MEETING DATE: September 9, 2025

PREPARED BY: Otis T. Spriggs, AICP, Development Services Director

AGENDA CONTENT: Discussion and possible action on the Preliminary Plat of Ashland Section 7B, located on the northeast curved section of Sapphire Springs Trail, east of Section 6, and north of Section 7A.

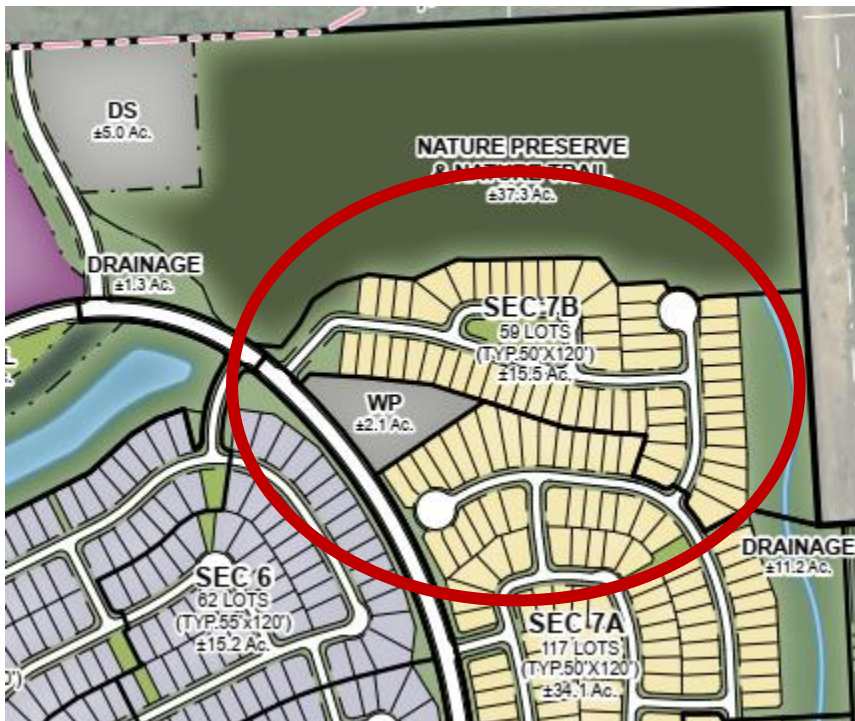
Ashland Development Section 7B Preliminary Plat comprises 26.11 acres, with 59 lots, 4 drainage, landscaping, open space, and utility reserves, and 4 blocks are proposed. The section is located on the northeast section of Sapphire Springs Trail, east of Section 6, and north of Section 7A. (see adjacent Land Plan). The majority of the lots in this section average approximately 50 ft. in width, with only a few 55-ft. lots, at 120' in depth.
